Donald C. Cook Nuclear Plant Units 1 and 2
RESPONSE TO REQUEST FOR ADDITIONAL INFORMATION
REGARDING UNIT 2 CONTROL ROD DRIVE MECHANISM VESSEL
HEAD PENETRATION JUSTIFICATION FOR SAFE OPERATION UNTIL
JANUARY 19, 2002

RESPONSE TO REQUEST FOR ADDITIONAL INFORMATION REGARDING UNIT 2 CONTROL ROD DRIVE MECHANISM VESSEL HEAD PENETRATION JUSTIFICATION FOR SAFE OPERATION UNTIL JANUARY 19, 2002

D. C. COOK UNIT 2 UPPER HEAD PENETRATION CRACK GROWTH DETERMINED
FROM INSPECTION DATA

Figure 5
Stress Intensity Factor Calculations for an Axial Inside Surface Flaw
In the D. C. Cook R. V. Head Penetration #75

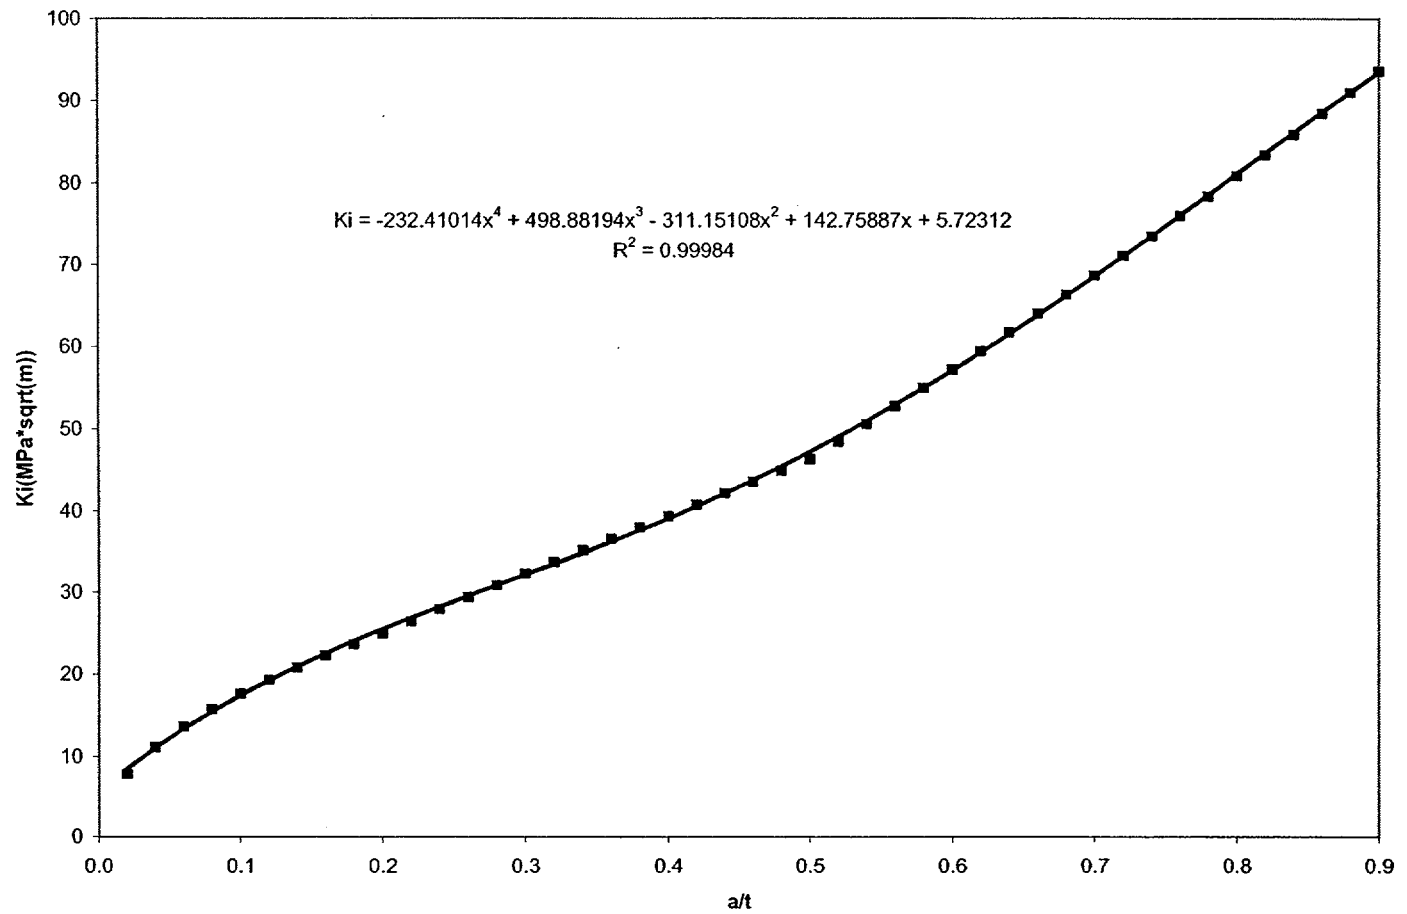
Please provide the documentation for the Cook 2 data point on the crack growth data graph on Slide 24 and the basis for the value "K" that the data point is plotted on. What are the uncertainties and justification of why the Cook 2 data point is applicable in this graph?

Plotting the data with the laboratory data requires determination of the stress intensity factor, K. This calculation was done using the Raju-Newman expression, and using the results of 3-D elastic plastic finite element analysis, which indicate that the stresses in this region are nominally at yield stress. The flaw shape (length/depth) was nominally 6.6, so the value 6 was used. This results in a value of $40.7 \text{ MPa} \sqrt{m}$, as seen in Figure 5.
